STATE OF NEW YORK
OFFICE OF GENERAL SERVICES
DESIGN AND CONSTRUCTION GROUP
THE GOVERNOR NELSON A. ROCKEFELLER
EMPIRE STATE PLAZA
ALBANY, NY 12242

ADDENDUM NO. 1 TO PROJECT NO. 44460

**CONSTRUCTION WORK AND ELECTRICAL WORK
PROVIDE TACTICAL FIRING RANGE
STATE PREPAREDNESS TRAINING CENTER
5900 AIRPORT ROAD
ORISANY, NY**

July 1, 2014

Building 3

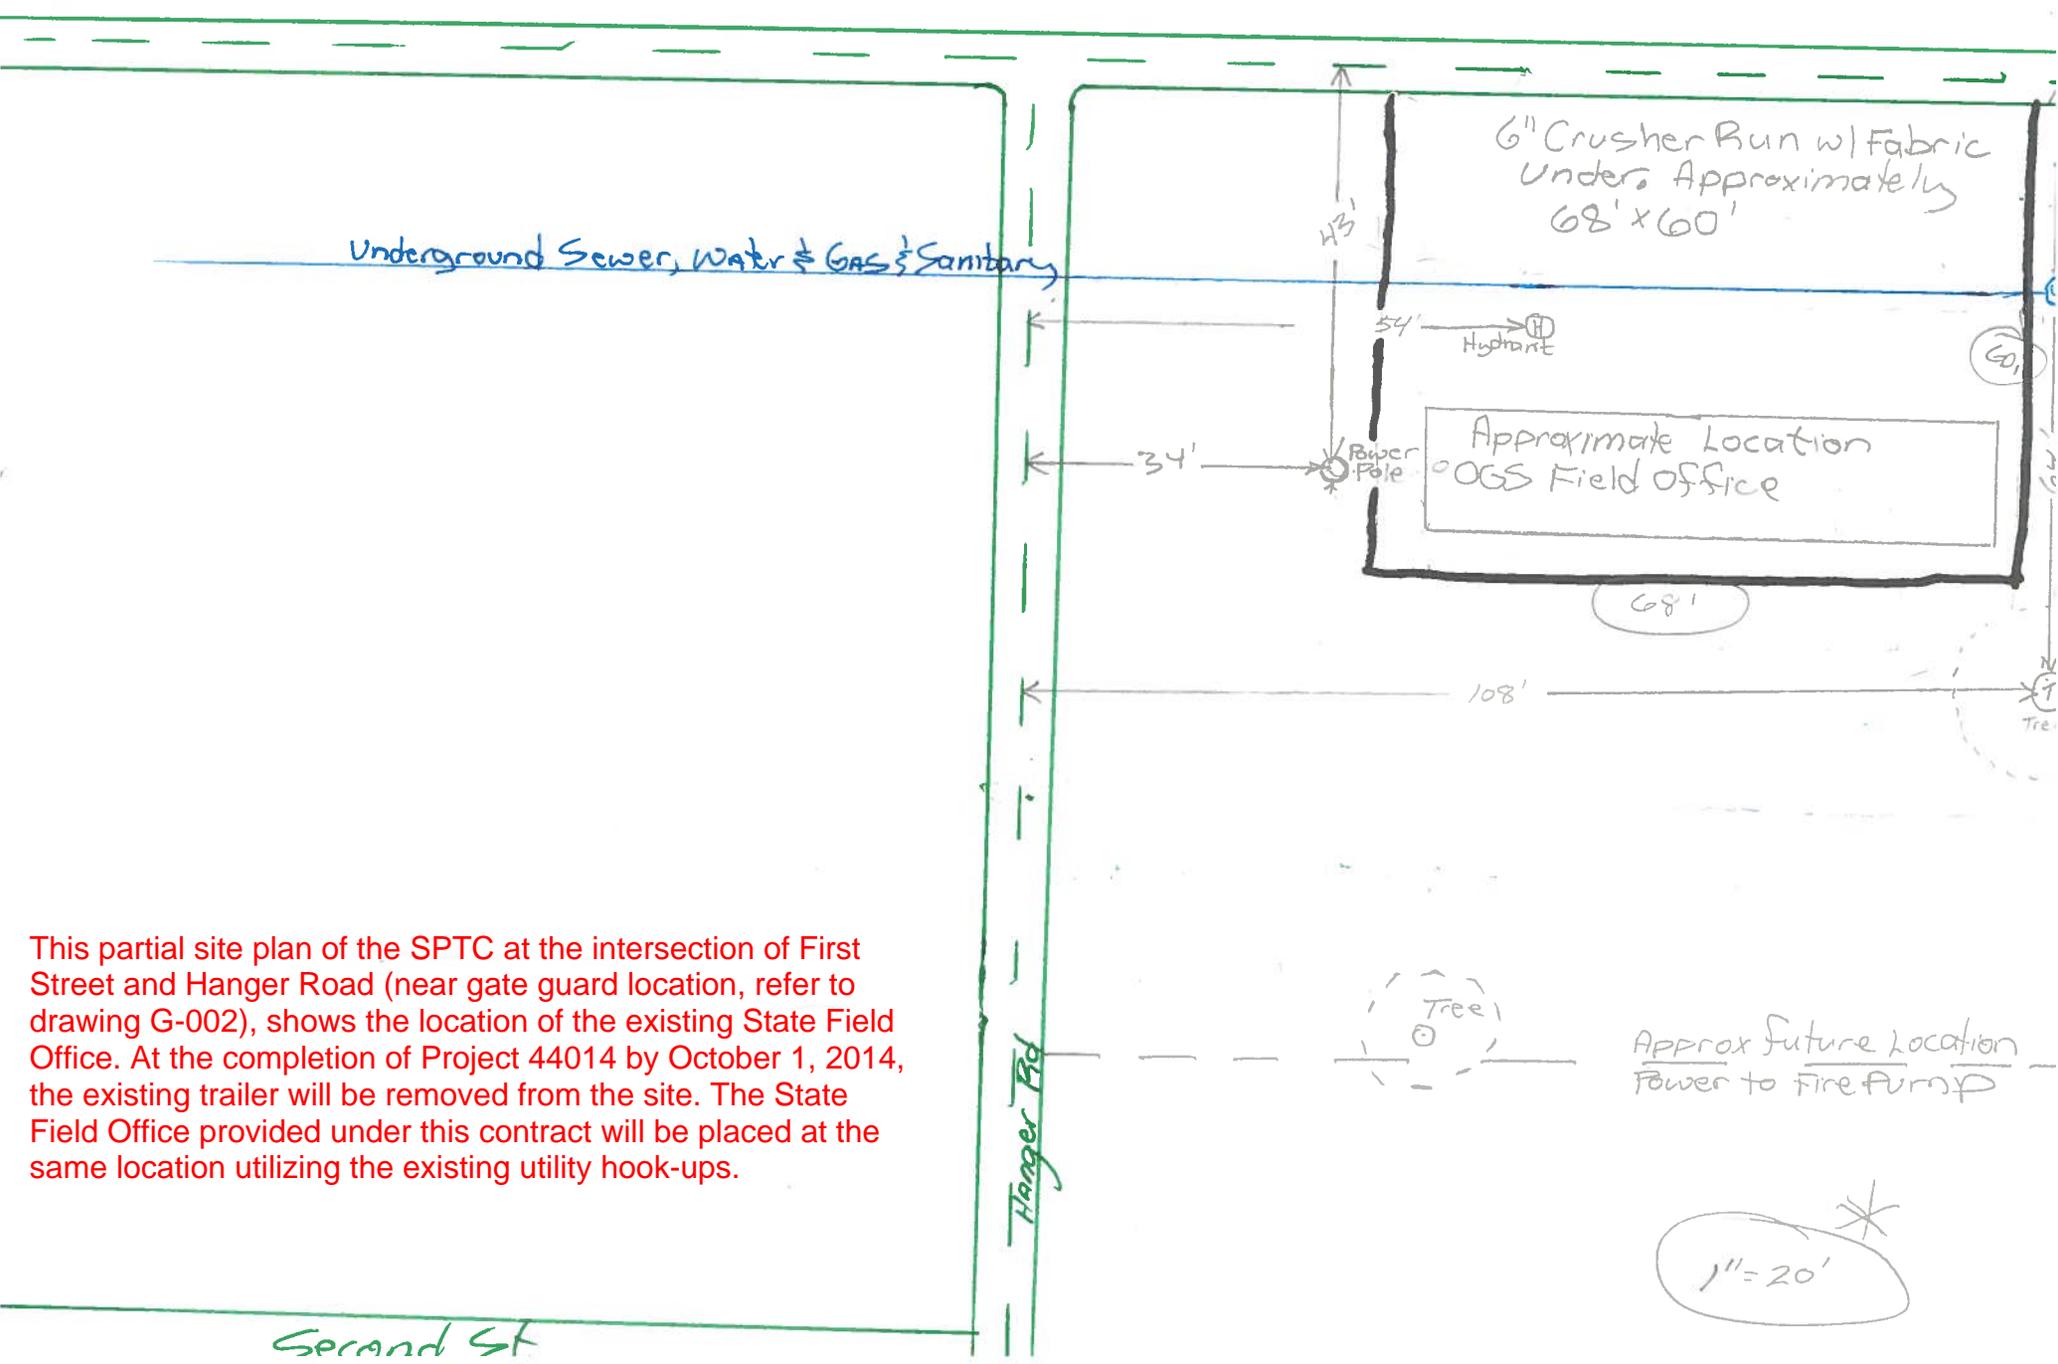
This partial site plan of the SPTC at the intersection of First Street and Hanger Road (near gate guard location, refer to drawing G-002), shows the location of the existing State Field Office. At the completion of Project 44014 by October 1, 2014, the existing trailer will be removed from the site. The State Field Office provided under this contract will be placed at the same location utilizing the existing utility hook-ups.
